Appl. No. 10/762,671
Amendment dated April 4, 2005
Reply to Office Action of December 2, 2004

Amendments to the Drawing:

FIG.11D-a

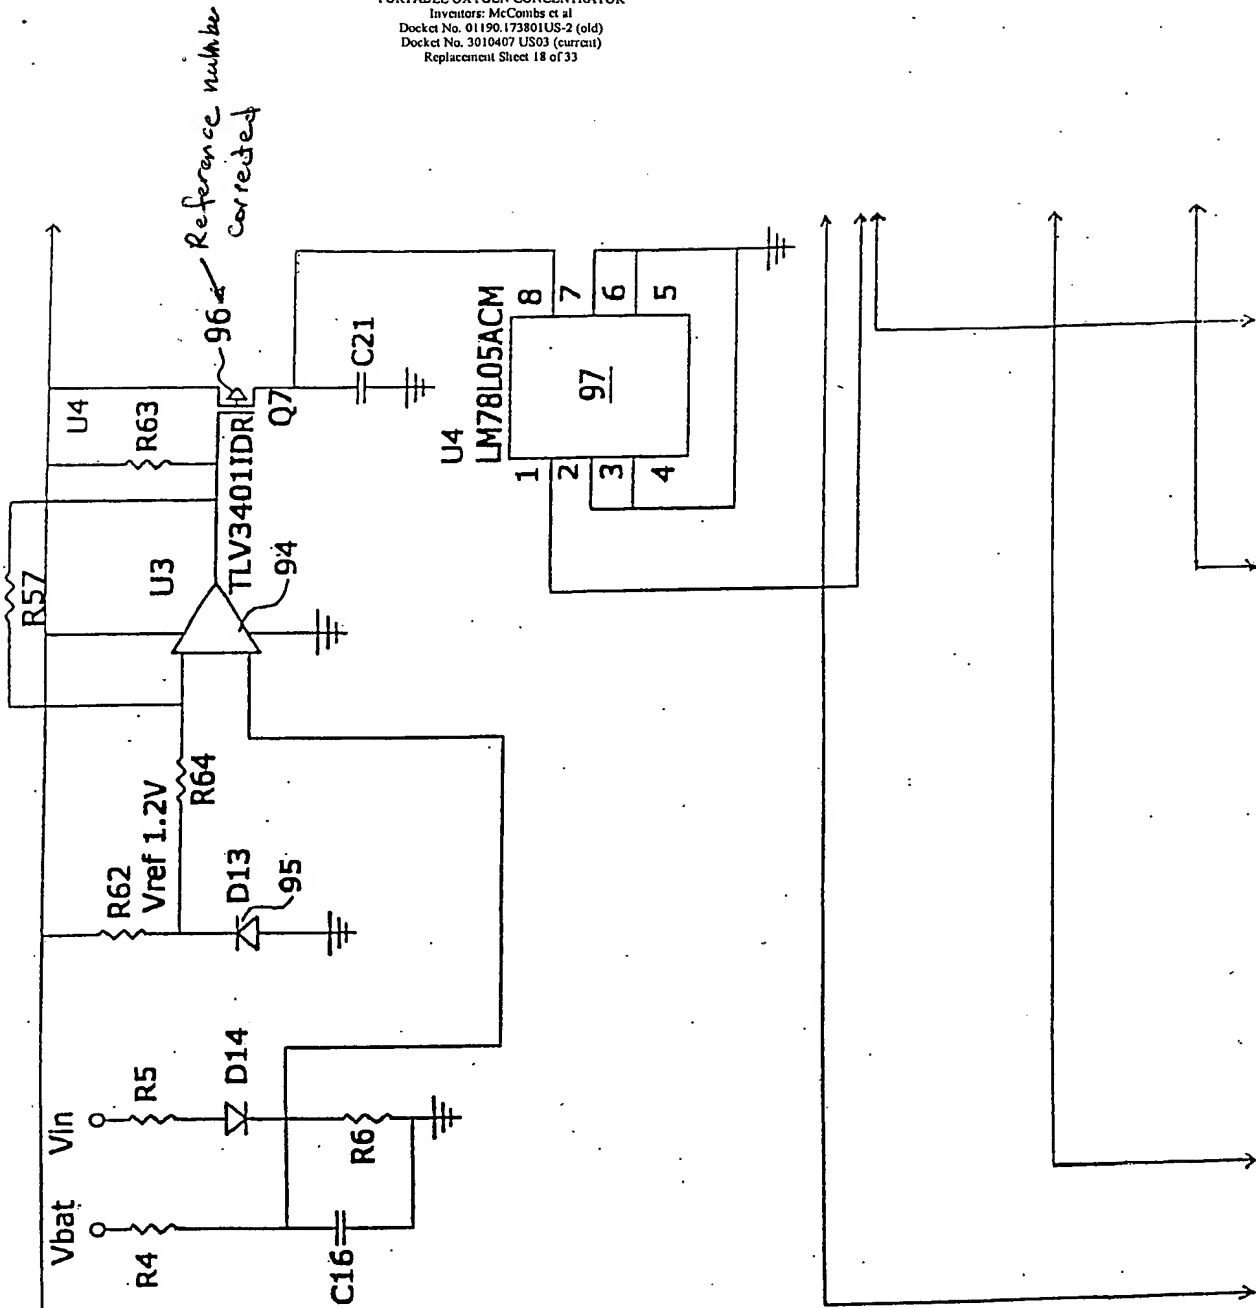
Please replace Drawing Sheets 14, 18 and 19, containing FIGS. 11C-a, 11D-a and 11D-b, respectively, with the attached amended and corresponding Drawing Sheets, in which missing reference numerals as noted by the Examiner are added and shown in red on the drawing copies that follow.
